'The "Golden Points" and nonequilibrium correction of high-accuracy frost point hygrometers' by Poltera et al.

Author response to reviewer comments

'Comment on egusphere-2025-2003', Anonymous Referee #2, 20 Jul 2025

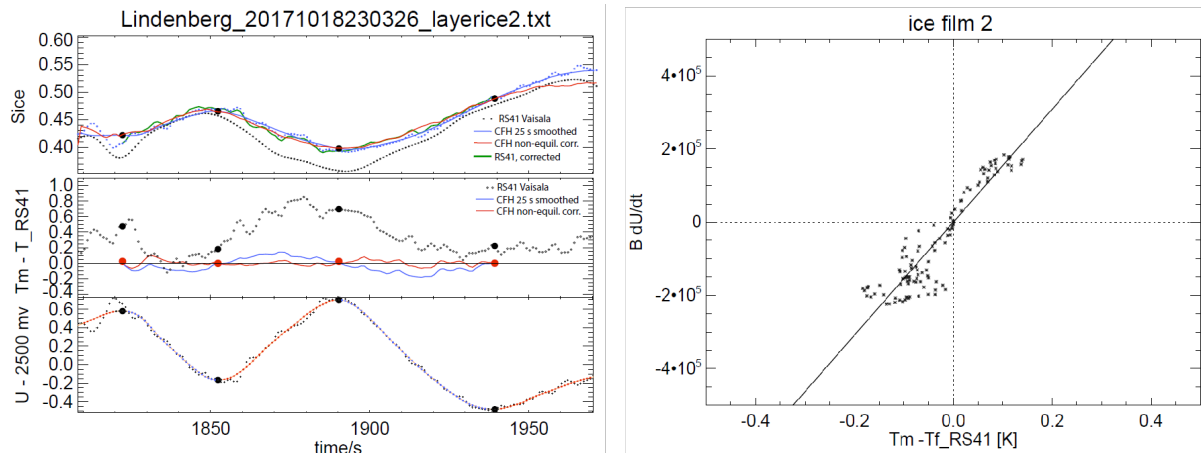
Do the authors know, what time constant Vaisala is using? If they are correcting the Vaisala RS41 data based on raw data, do they use the relative humidity at sensor temperature or that at ambient temperature? What smoothing is applied to the RS41 time lag corrected data? How does their time lag correction compare to that applied by Vaisala?

We have estimated the RS41 time constant used by Vaisala MW41 by comparing raw and final data. About 10 s at -40 C and 100 s at -70 C sensor temperature, with exponential relationship, similarly to RS92 (Dirksen et al., 2014).

We apply the time-lag correction on the relative humidity at sensor temperature, not ambient temperature. Then smooth the result (boxcar of 25 s) and convert back to frost point. Our time-lag correction usually differs from that of Vaisala in the -30 C -60 C temperature regime, with our time constants being about 40% smaller.
